From: Dennis M. Postler <dennis.postler@tkda.com>
Sent: Thursday, June 18, 2020 2:49 PM
To: Elizabeth Mursko <cityadministrator@ci.columbus.mn.us>; Jim Windingstad <jwsuperintendent@ci.columbus.mn.us>
Cc: Larry Poppler <larry.poppler@tkda.com>
Subject: FW: N.698146 / MNCL19.80163E_Hornsby St Realignment-Columbus

**HORNSBY STREET
 NORTH REALIGNMENT**

DRAINAGE PLAN AND PROFILE
 TH 97 STA. 417+83.82 TO STA. 433+00

DRAINAGE PLAN AND PROFILE
 TH 97 STA. 417+83.82 TO STA. 433+00

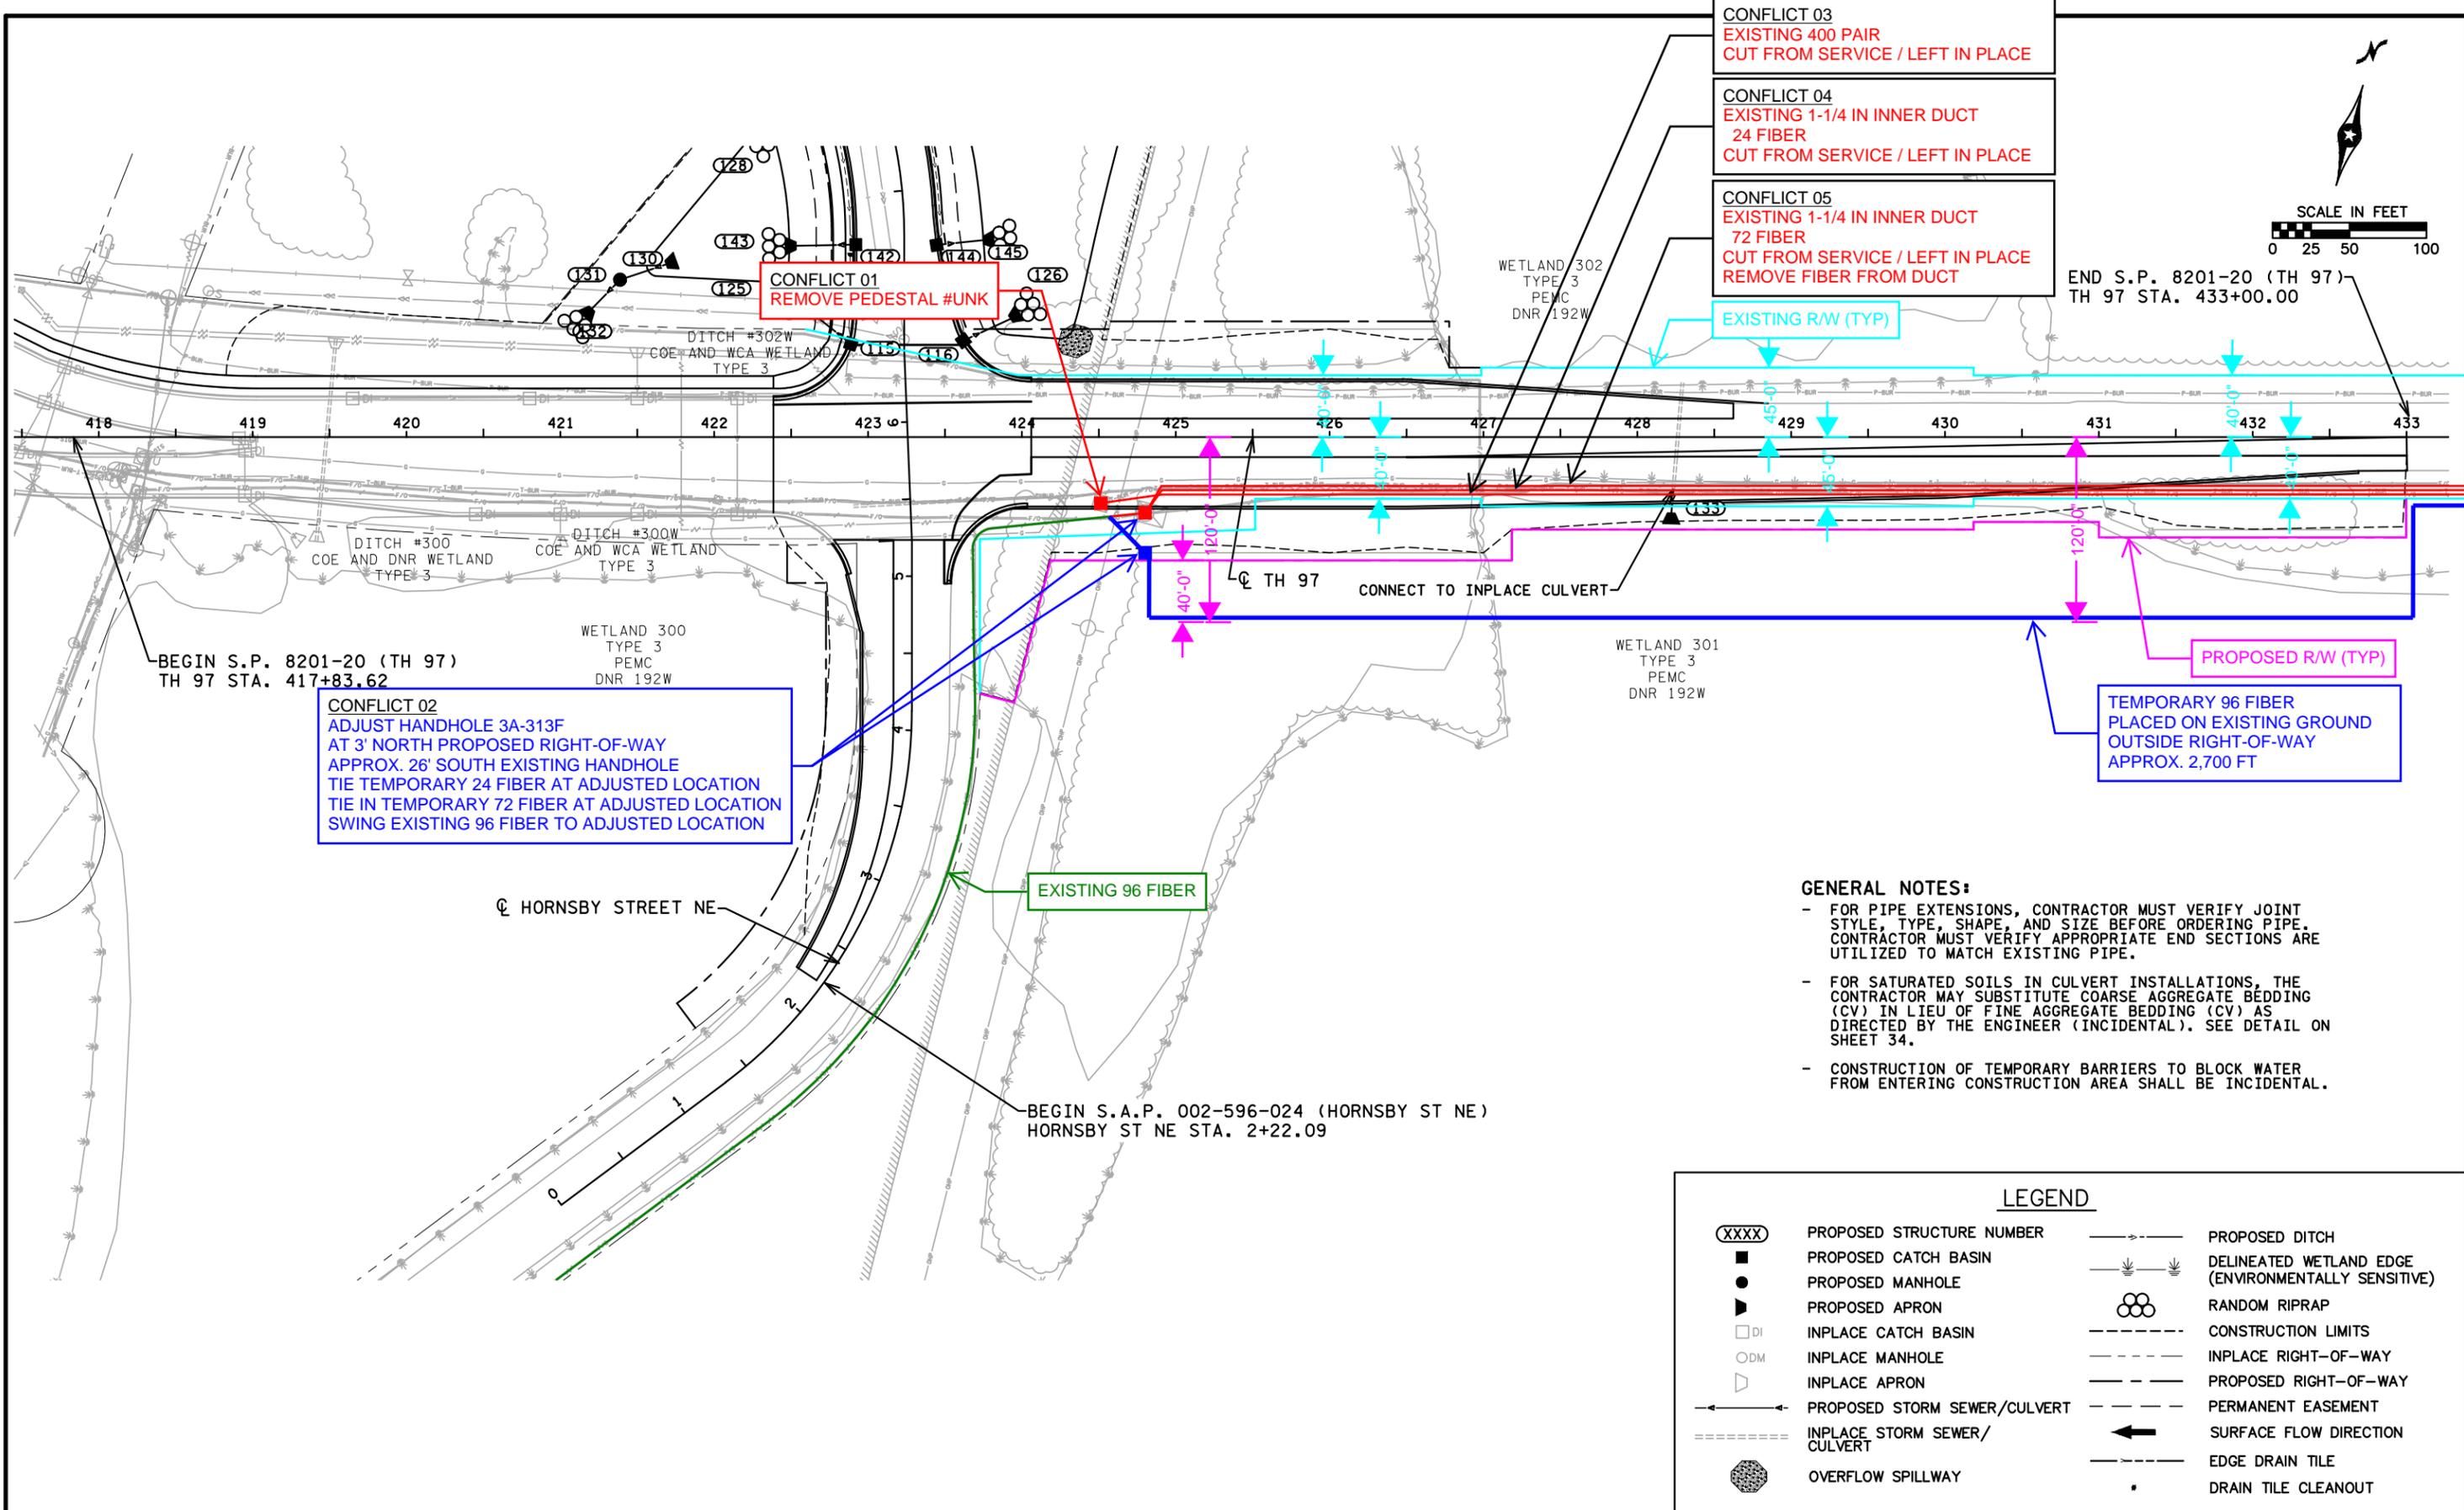
CONFLICT 02
 ADJUST HANDHOLE 3A-313F
 AT 3' NORTH PROPOSED RIGHT-OF-WAY
 APPROX. 26' SOUTH EXISTING HANDHOLE
 TIE IN TEMPORARY 24 FIBER AT ADJUSTED LOCATION
 TIE IN TEMPORARY 72 FIBER AT ADJUSTED LOCATION
 SWING EXISTING 96 FIBER TO ADJUSTED LOCATION

CONFLICT 01
 REMOVE PEDESTAL #UNK

CONFLICT 03
 EXISTING 400 PAIR
 CUT FROM SERVICE / LEFT IN PLACE

CONFLICT 04
 EXISTING 1-1/4 IN INNER DUCT
 24 FIBER
 CUT FROM SERVICE / LEFT IN PLACE

CONFLICT 05
 EXISTING 1-1/4 IN INNER DUCT
 72 FIBER
 CUT FROM SERVICE / LEFT IN PLACE
 REMOVE FIBER FROM DUCT

CONSTRUCTION PLAN

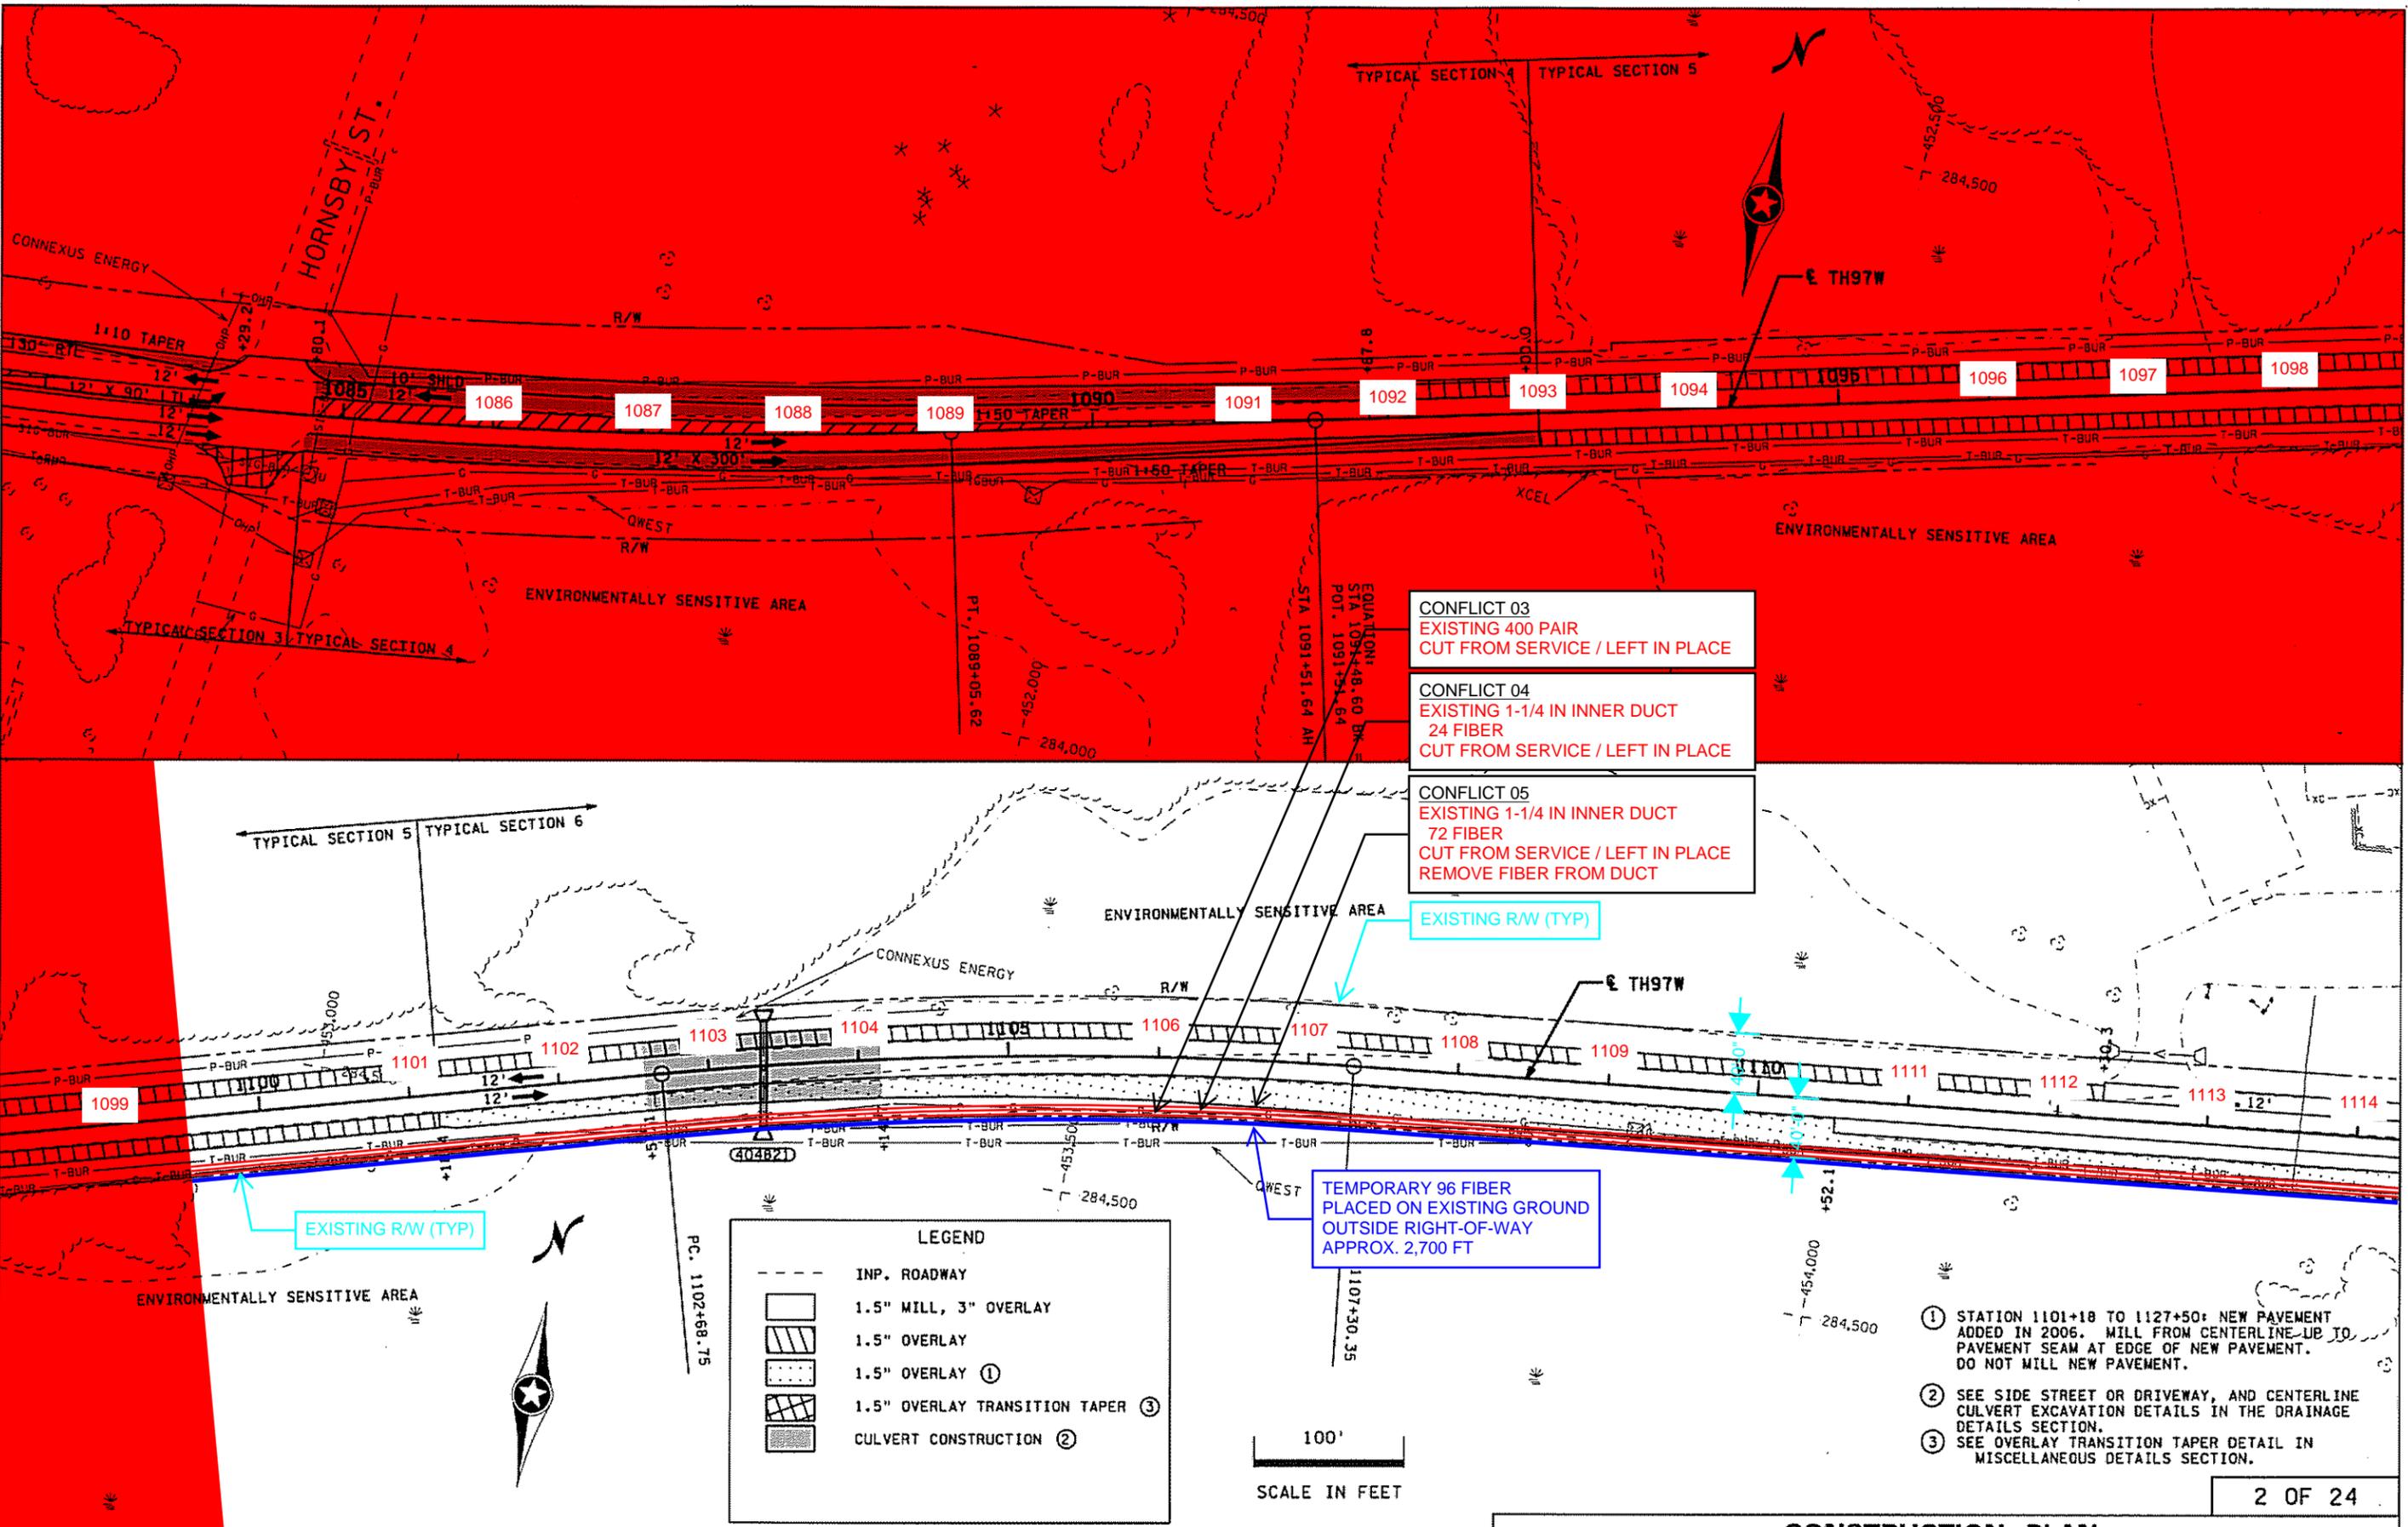
- CONFLICT 03
EXISTING 400 PAIR
CUT FROM SERVICE / LEFT IN PLACE
- CONFLICT 04
EXISTING 1-1/4 IN INNER DUCT
24 FIBER
CUT FROM SERVICE / LEFT IN PLACE
- CONFLICT 05
EXISTING 1-1/4 IN INNER DUCT
72 FIBER
CUT FROM SERVICE / LEFT IN PLACE
REMOVE FIBER FROM DUCT

TEMPORARY 96 FIBER
PLACED ON EXISTING GROUND
OUTSIDE RIGHT-OF-WAY
APPROX. 2,700 FT
